**James City County Environmental Division  
Stormwater Management/BMP Record Drawing and  
Construction Certification Review Tracking Form**

Project Name: Chickahominy Riverfront Park EV Loop  
 County Plan No.: SP-0009-2010  
 Stormwater Management Facility: \_\_\_\_\_  
 BMP Phase #:  I  II  III  
 Information Package Received. Date/By: 12/7/2011  
 Completeness Check:  
    Record Drawing Date/By: 12/7/11 Thomas Sublett  
    Construction Certification Date/By: 12/7/11 Herman Small  
    RD/CC Standard Forms (Required for all BMPs after Feb 1<sup>st</sup> 2001 Only)  
      Insp/Maint Agreement # / Date: N/A  
      BMP Maintenance Plan Location: N/A  
      Other: Volunteer installation  
 Standard E&SC Note on Approved Plan Requiring RD/CC or County comment in plan review  
    Yes  No Location: \_\_\_\_\_  
 Assign County BMP ID Code #: Code: ~~RD~~ GCOIS  
 Preliminary Input/Log into Division's "As-Built Tracking Log"  
 Add Location to GIS Map. Obtain basic site information (GPIN, Owner, Address, etc.)  
 Preliminary Log into Access Database (BMP ID #, Plan No., GPIN, Project Name, etc.)

Project Name:	Chickahominy Riverfront Park RV Area
Structure/BMP Name:	Stormwater Ca

Sheet Number  
**06**

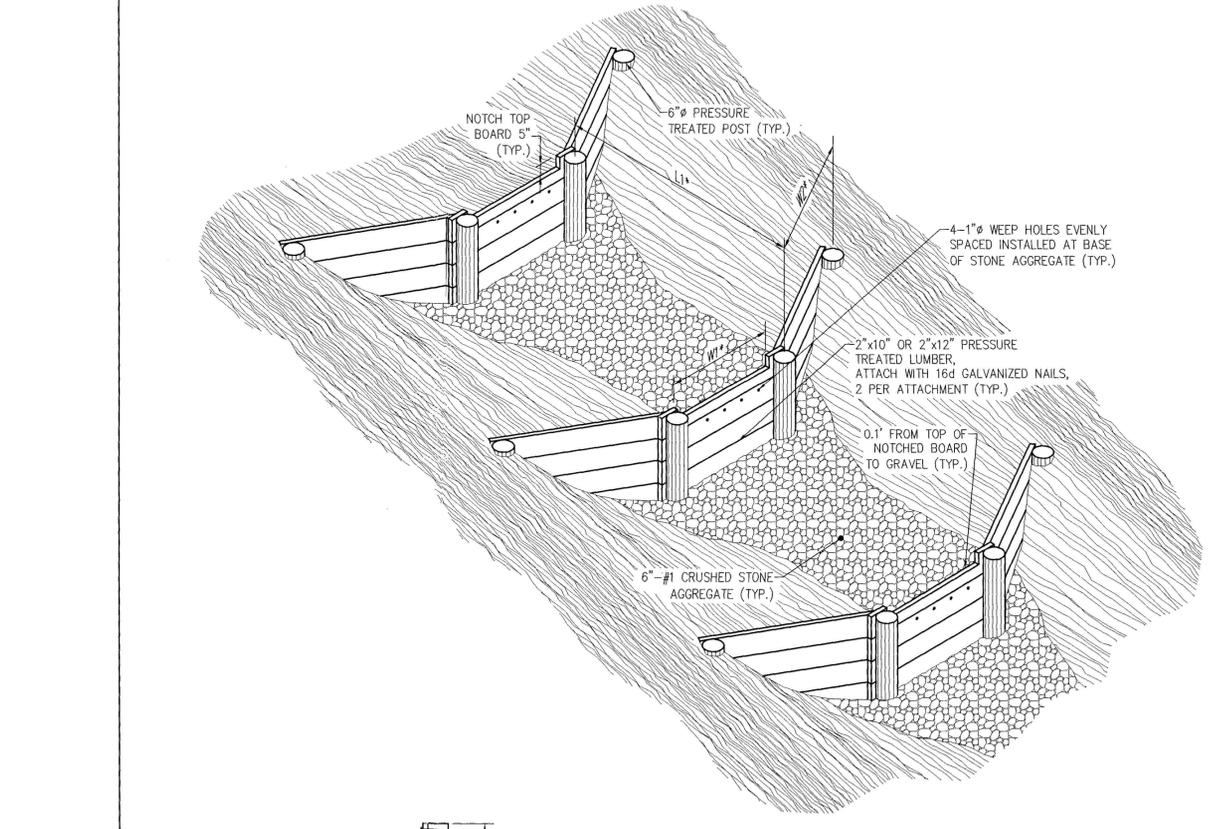
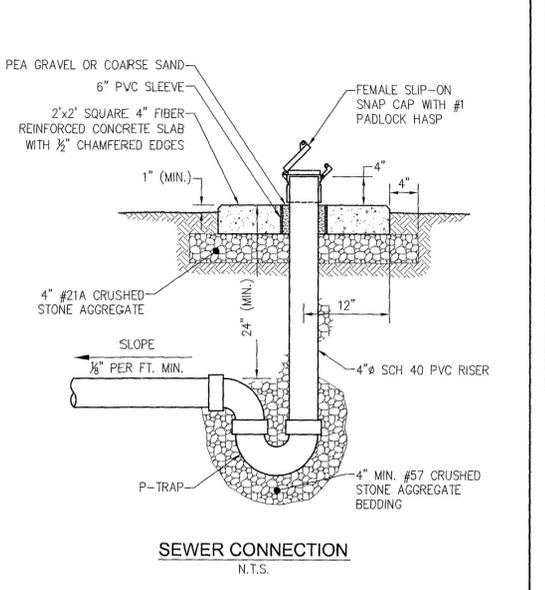
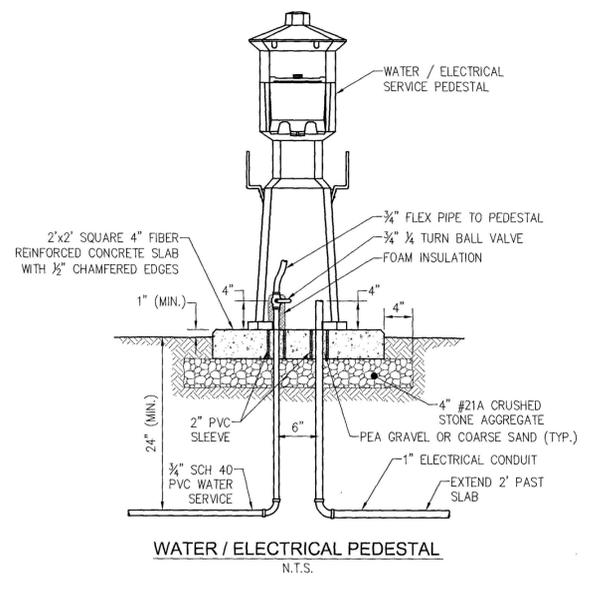
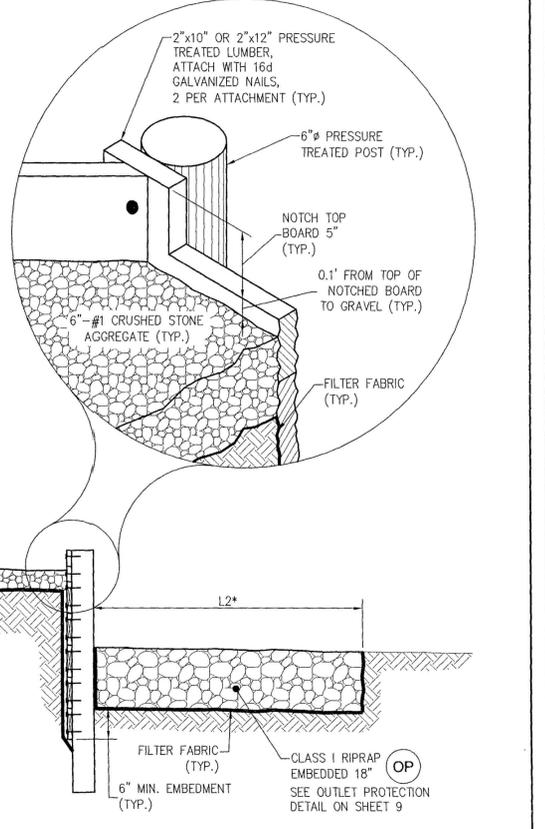
*Filter fabric has been added under the Class I rip rap at the base of the structure and a note added to see the Outlet Protection Detail on Sheet 9.*
